Product Change Notification					PCN FMW-41 and FMLB case 41 redesign		
owner	creation date	release date	released by	change order no	rev	page	D10-041-450
doriaan	04.12.2019	04.12.2019	romanogu	2018651	A	1 of 2

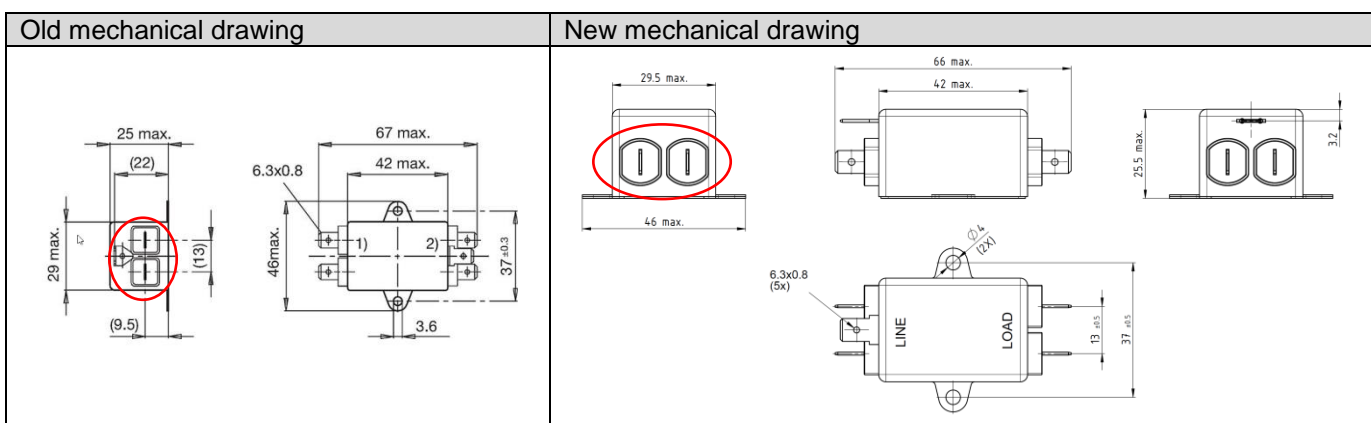
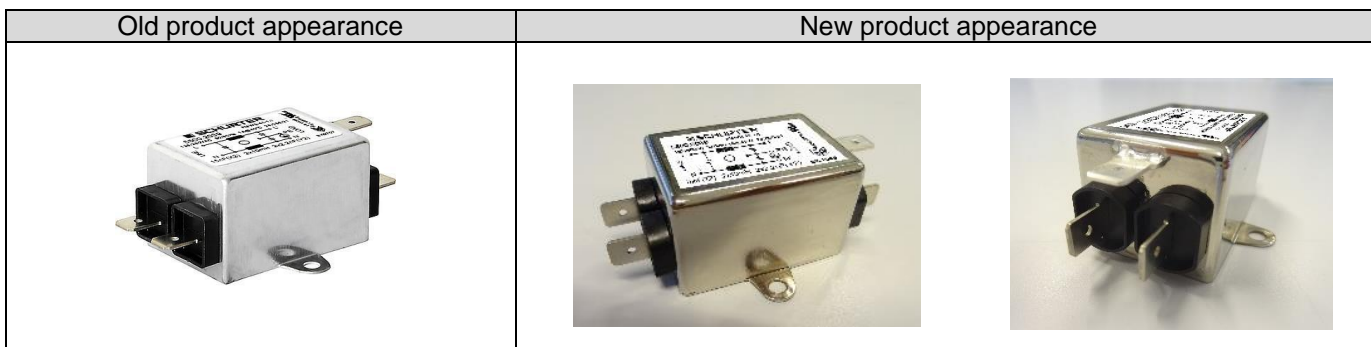
- Nickel plated steel case instead of aluminium case
- Different orientation of external quick connect terminals
- Change of production site

- Change of product appearance due to new nickel plated steel case instead of aluminium case
- Different shape and orientation of plastic part for external quick connector terminals
- New cases are provided with a bottom cover
- Change of factory code from SK to SC and origin from SK to CN on product and packaging labels
